**Seattle
Design
Commission**

**APPROVED
MINUTES OF THE MEETING
20 June 2002**

Projects Reviewed

ZymoGenetics
Olympic Sculpture Park
Automated Public Toilet
Cheasty Boulevard
Westcrest Park

Conceptual site model, looking southeast
-www.seattleartmuseum.org

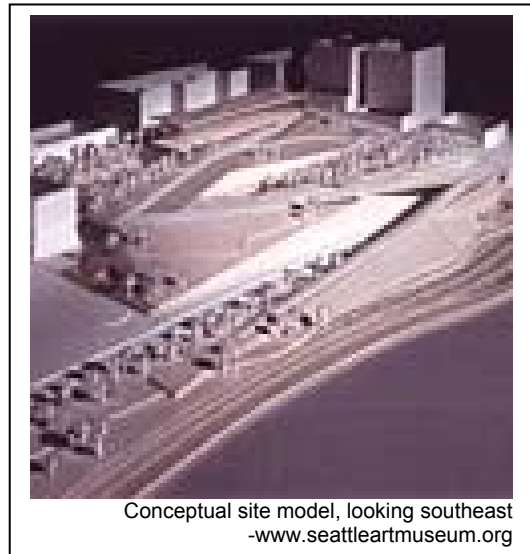
- Would like the design team to explain the Broad Street edge and pedestrian experience of the park. Would like to know why there is a large wall along the street, near the intersection of Broad Street and Western Avenue.

- Proponents stated that this wall has been exaggerated in the model. This wall is meant to define the entry point to the pavilion at the corner, as well as mark the entry to the

parking garage. The design at this corner reflects the need for natural light within the parking garage. Further stated that this is the park's strongest urban edge, but very noisy and it is also an amorphous intersection. The design of this corner will create a distinctive corner for the park.
